FLYING HORSE NORTH
COUNTY OF EL PASO, STATE OF COLORADO
IRRIGATION RESERVOIR EMBANKMENT

<p>48 HOURS BEFORE YOU DIG, CALL UTILITY LOCATORS</p> <p>811</p> <p>UTILITY NOTIFICATION CENTER OF COLORADO IT'S THE LAW</p> <p>THE LOCATIONS OF EXISTING UNDERGROUND UTILITIES ARE SHOWN IN AN APPROXIMATE WAY ONLY. THE CONTRACTOR SHALL DETERMINE THE EXACT LOCATION OF ALL EXISTING UTILITIES BEFORE COMMENCING WORK. THE CONTRACTOR SHALL BE FULLY RESPONSIBLE FOR ANY AND ALL DAMAGES WHICH MIGHT BE CAUSED BY HIS FAILURE TO EXACTLY LOCATE AND PRESERVE ANY AND ALL UNDERGROUND UTILITIES.</p>	NO. REVISION		DATE	<p>REVIEW:</p> <p>PREPARED UNDER MY DIRECT SUPERVISION FOR AND ON BEHALF OF CLASSIC CONSULTING ENGINEERS AND SURVEYORS, LLC</p> <p>MARC A. WHORTON, P.E. #37155</p> <p>DATE</p>	<div style="text-align: center;">  <p>CLASSIC CONSULTING ENGINEERS & SURVEYORS</p> </div> <p>619 N. Cascade Avenue, Suite 200 (719)785-0790 Colorado Springs, Colorado 80903 (719)785-0799(Fax)</p>	<p>FLYING HORSE NORTH IRRIGATION RESERVOIR EMBANKMENT</p> <p>WELL SITE / TEST REPORTS</p>

CLASSICSM CONSULTING ENGINEERS & SURVEYORS	FLYING HORSE NORTH IRRIGATION RESERVOIR EMBANKMENT				
	PUMP STATION PLAN / DETAILS				
	DESIGNED B

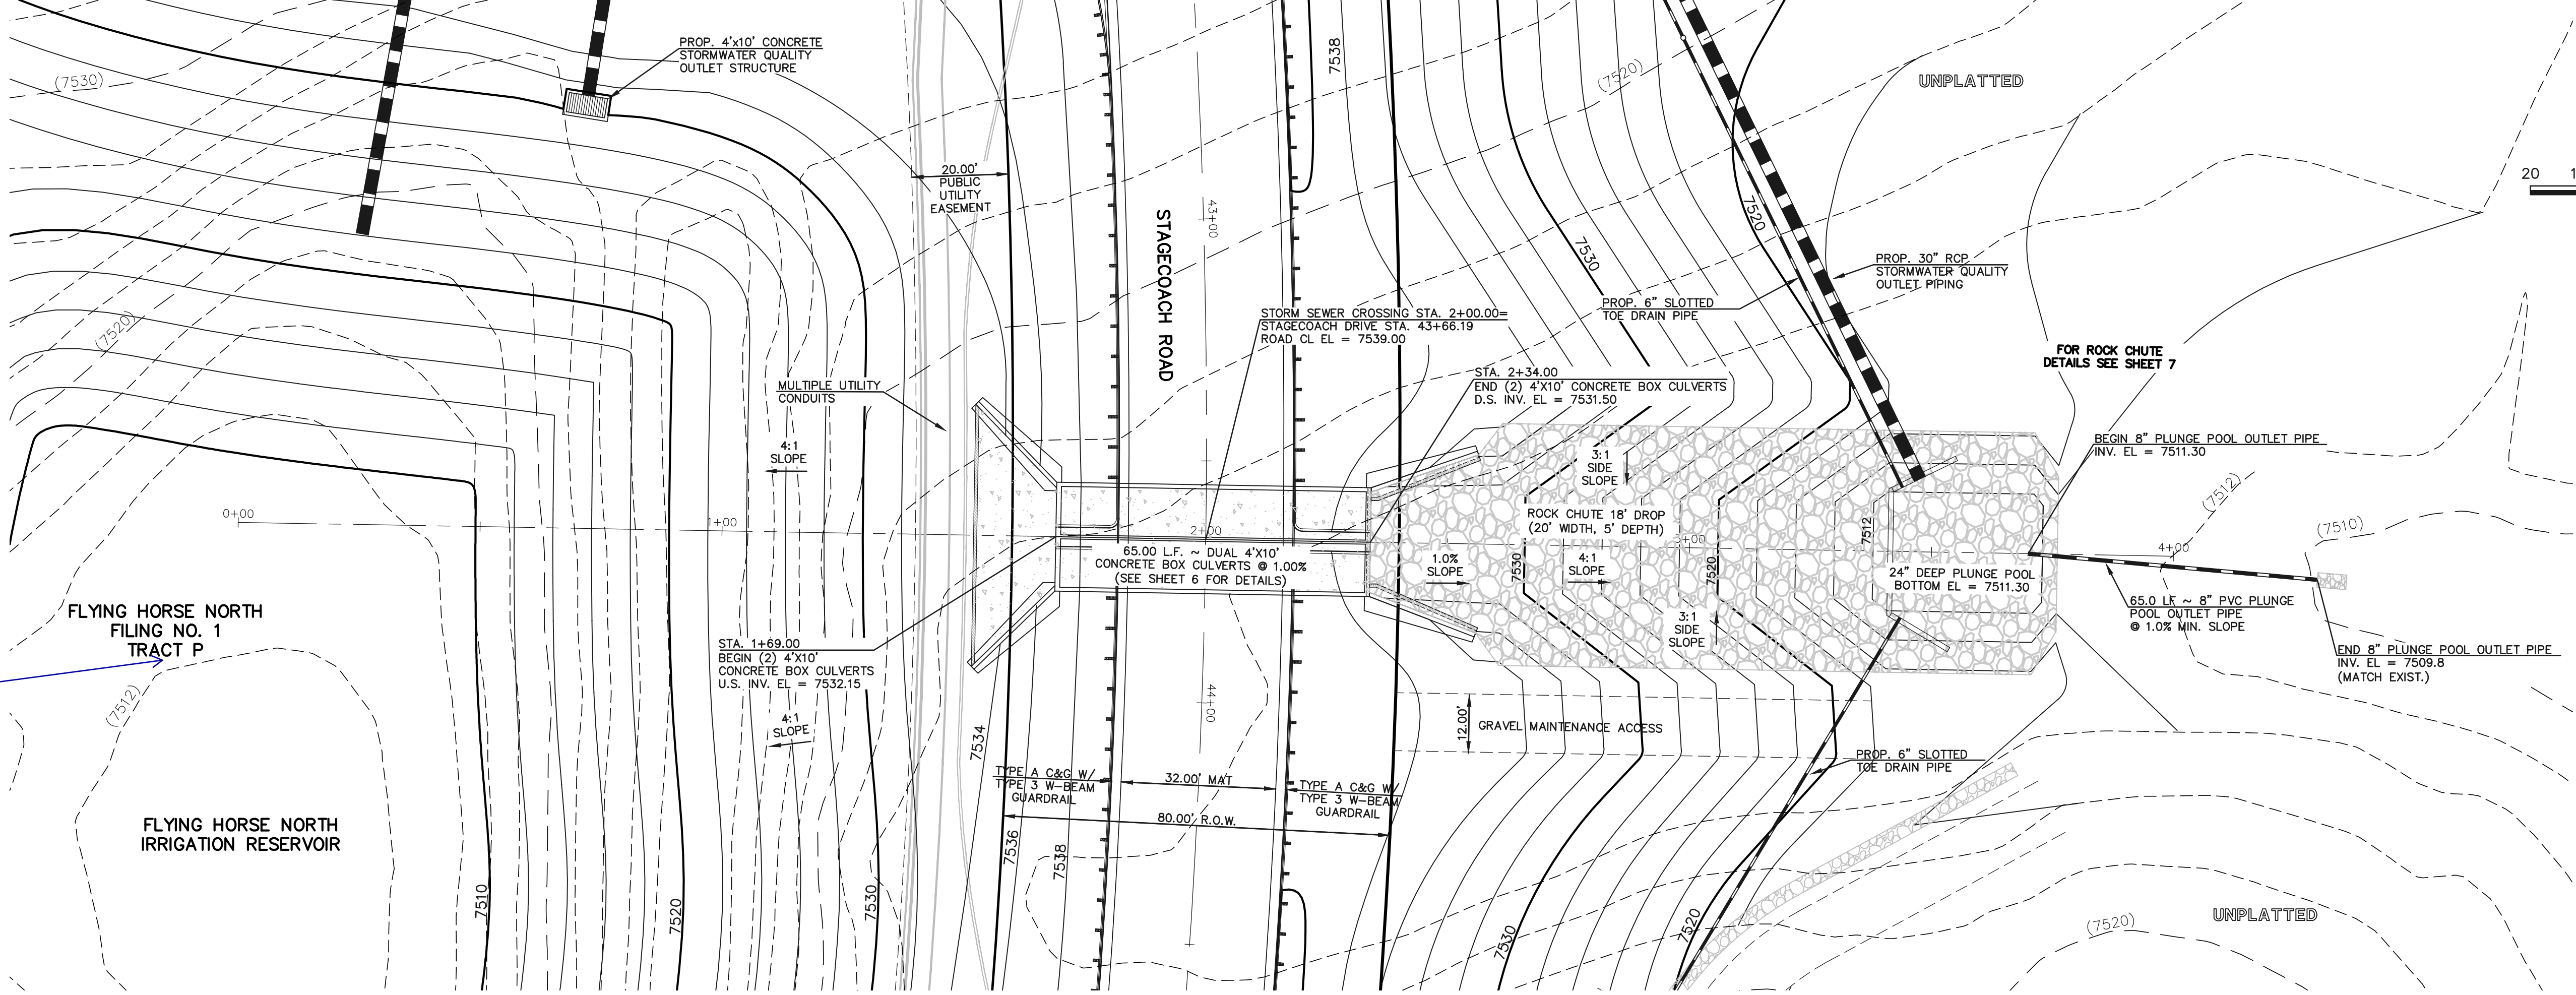
Revise to Tract L per the final plat.
